RE: Percolation Test Report, McCampbell Property, 18235 Penn Shop Road,
A530347

Re: Campbell Property
18235 Penn Shop Road
Sandmound Design

RE: Russell Campbell Property, 18235 Penn Shop Road, A530347

SCALE: AS SHOWN	APPROVED: JDC	DRWN: RSK
DATE: MAY, 2009	JDC	DES: JDC
RUSSELL CAMPBELL PROPERTY * 18235 PENN SHOP ROAD		
REPLACEMENT SYSTEM SANDMOUND		DRAWING NO. OF

SITE PLAN
SCALE: 1" = 30'

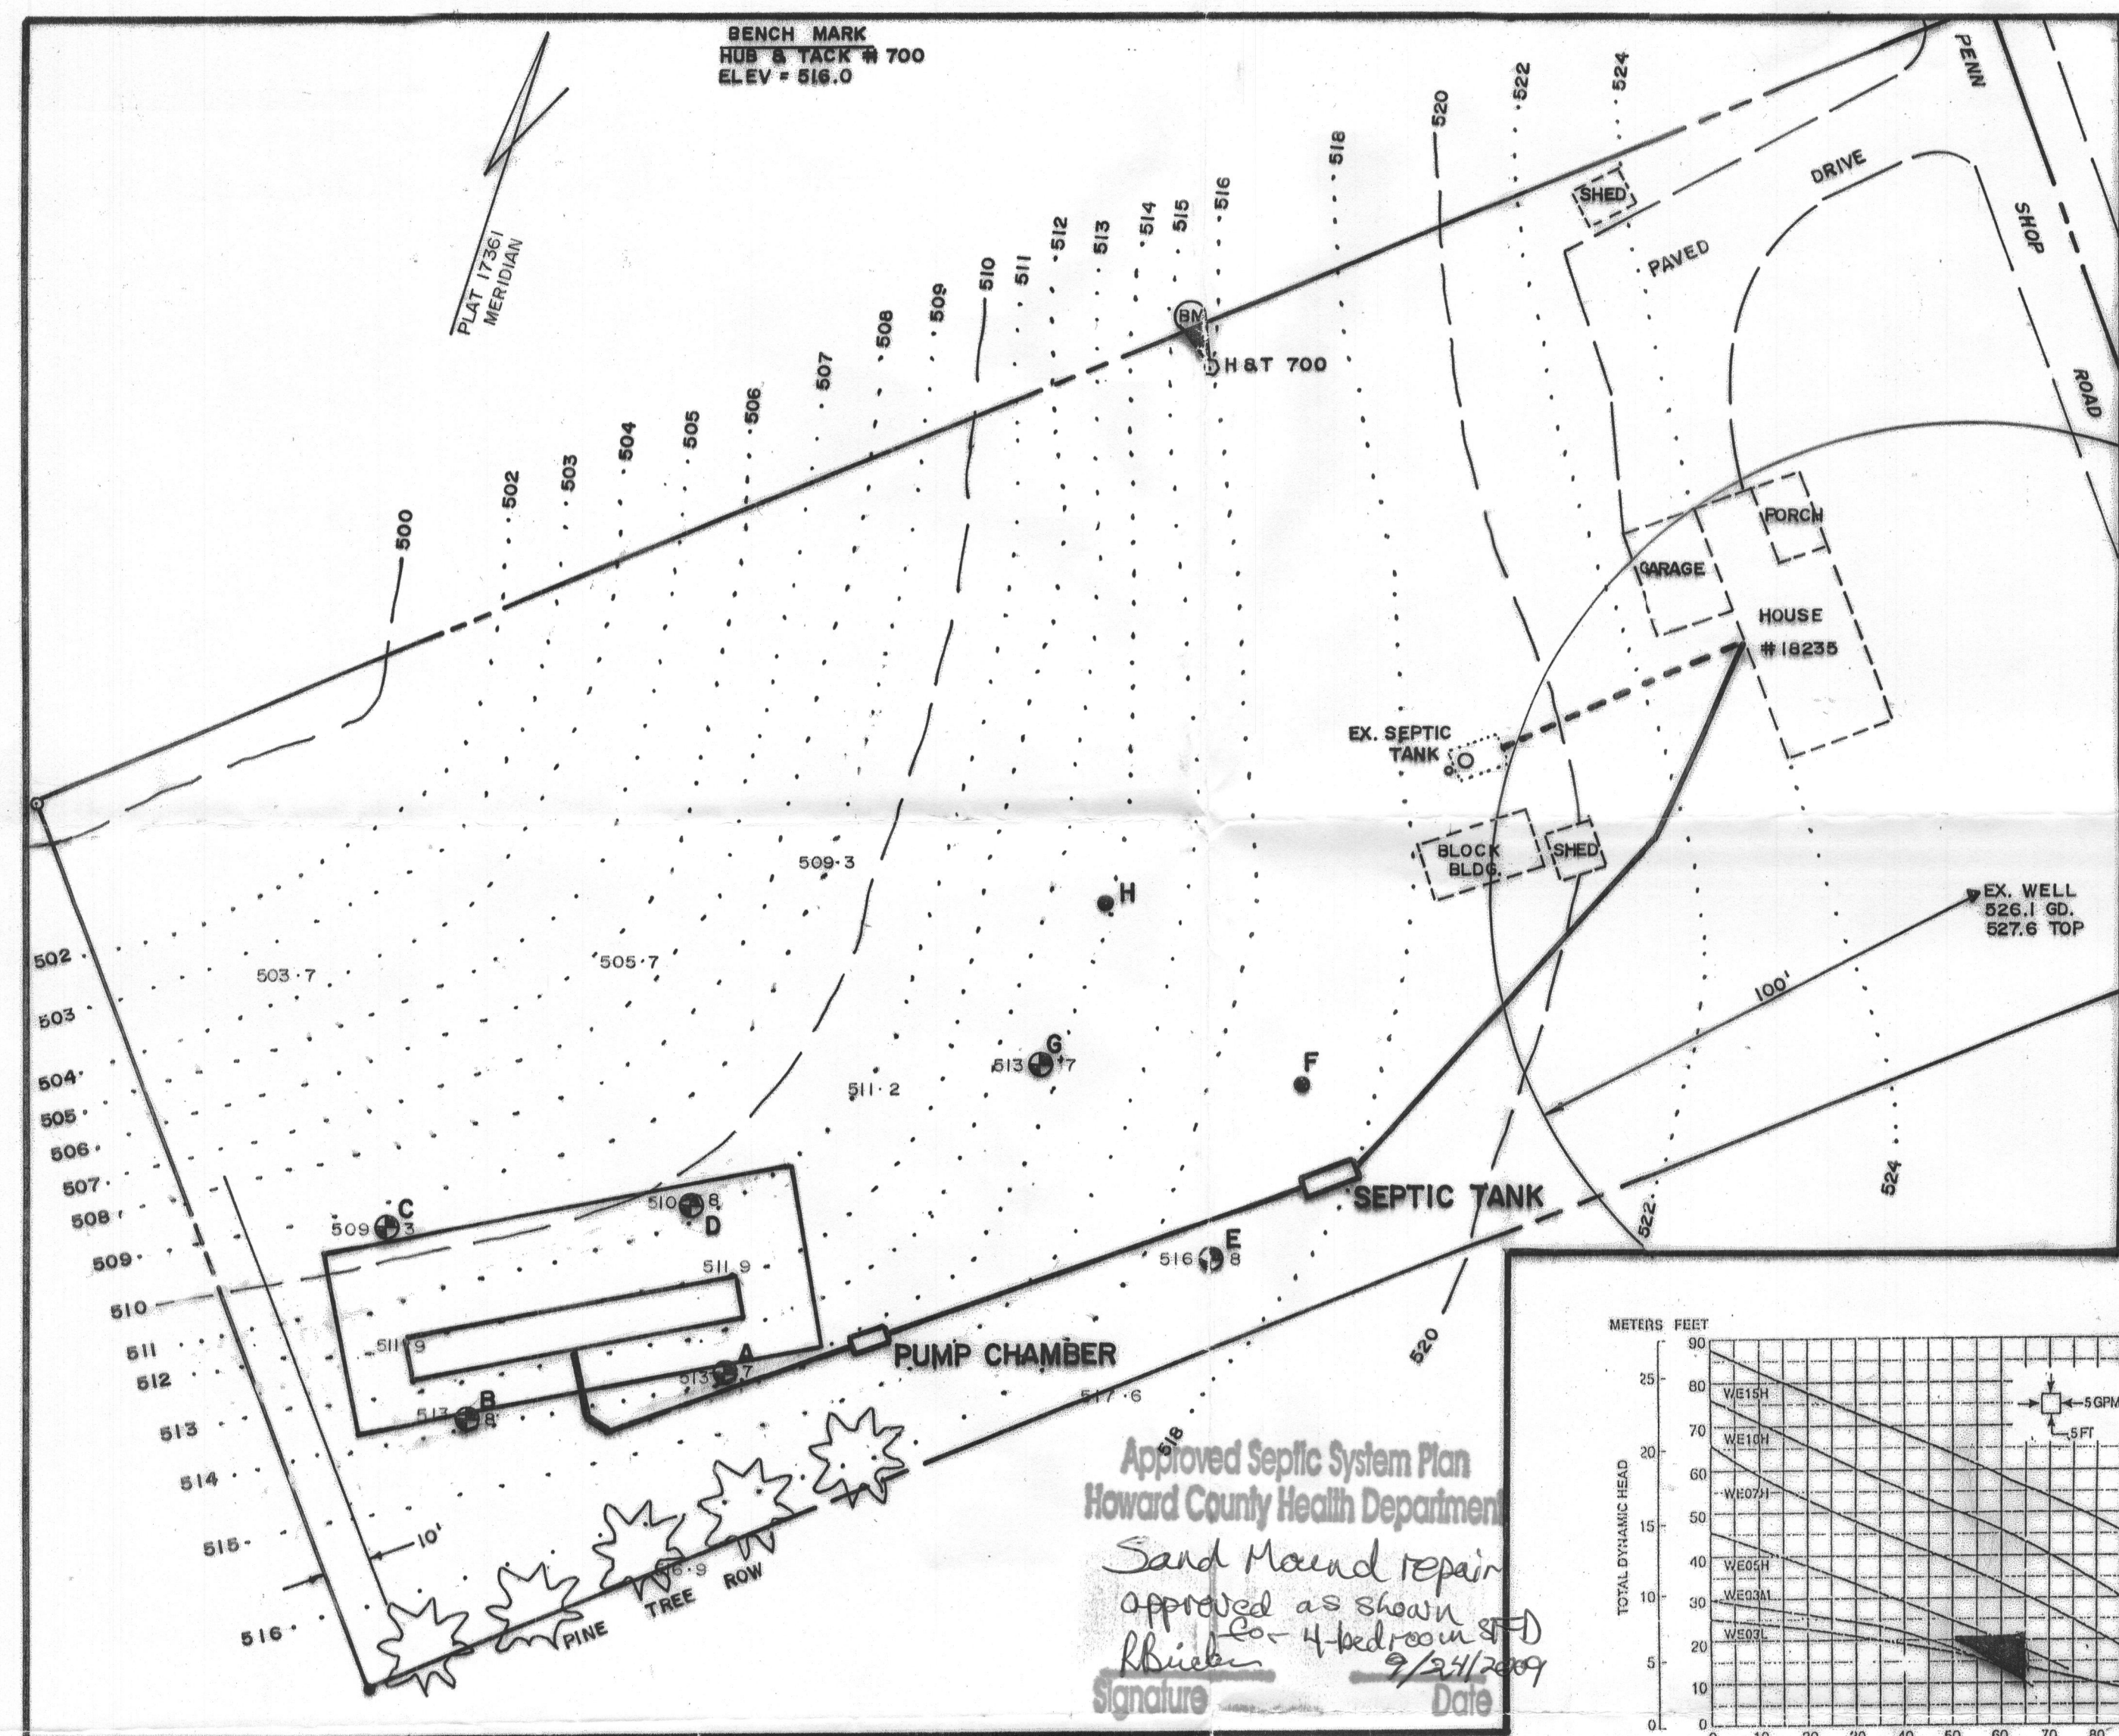
1. SOIL TEST. The correct times (min.) by respective test locations: A, 24; B, 32; C, 32; D, 12; E, 24; F, failed; G, 32; H, failed.
2. Lateral End Turn-Ups need to be on all 4 laterals.
3. The turn-ups need to be protected by sleeves as shown in Figure 4.5 of the Sand Mound Design Manual.
4. Observation pipes should be in the mound as indicated in Figure 3.1 of the Sand Mound Design Manual.
5. Concerning the site plan drawing:
 - a. Presentation of field-run elevation contours at 1-foot intervals is required.
 - b. The elevations of the 2 low corners of the sand mound should be presented (and be the same).
 - c. The elevations of the 2 low corners of the gravel bed should be shown.

5. Field run 1-foot contours are shown and identified. Elevations requested on low corners of the mound and sandbed are shown.

REVISED: 8/24/09 PER HEALTH DEPT. LETTER DATED 8/6/09 JDC
 9/14/09 PER R. BRICKER, HEALTH DEPT. ROTATE MOUND, ADD SPOT ELEV'S JDC
